NOTICE OF NON-PERFORMANCE

On October 7, 2025, Energy Safety conducted an inspection of San Diego Gas & Electric Company's WMP initiatives in the vicinity of the city of Valley Center, California. The inspection report is enclosed herewith. Energy Safety found the following deficiencies:

INSPECTION REPORT

GIimg2: Structure ID

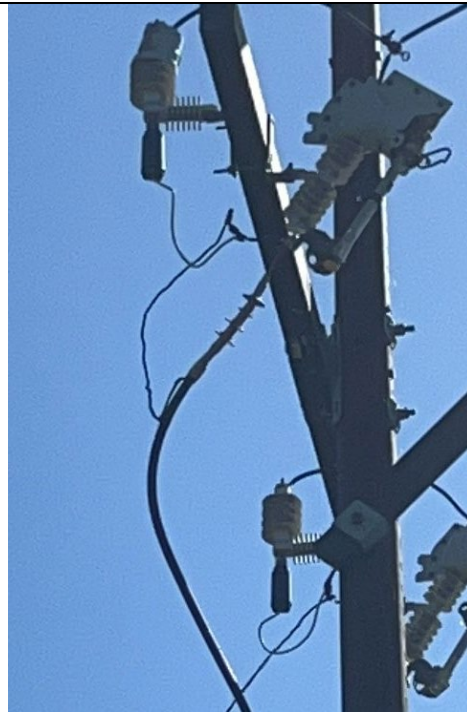
On pole ID P213266, Grid Hardening ID 530000366779-P213266 at 30601-30671 Ranch Creek Rd, Valley Center, CA, 92082, USA, 33.269487, -117.010332, the inspector observed that avian protection was missing from the lightning arrester. The inspector's observation is documented in Deficiency 1 photographs, which are attachments to this report. Photo numbers IA1Img1, IA1Img2 and IA1Img3 depict missing avian protection.

1. San Diego Gas & Electric Company's 2025 WMP Initiative 8.1.4.6 – Lightning Arrester Removal and Replacement work was identified as complete at this location.
2. The lightning arresters' cover was missing.
3. SDG&E Electric Overhead Construction Standard OH1640.1 states that “all lightning arresters require cover-up”.⁶

Deficiency 1. Energy Safety observed that in implementing 2025 WMP 8.1.4.6 – Lightning Arrester Removal and Replacement (WMP.550), SDG&E failed to complete lightning arrester installation on pole ID P213266, Grid Hardening ID 530000366779-P213266 at coordinates 33.269487, -117.010332. Energy Safety considers this nonperformance to be in the Minor risk category. SDGE must complete a corrective action for this deficiency by 12 months from date of this notice.
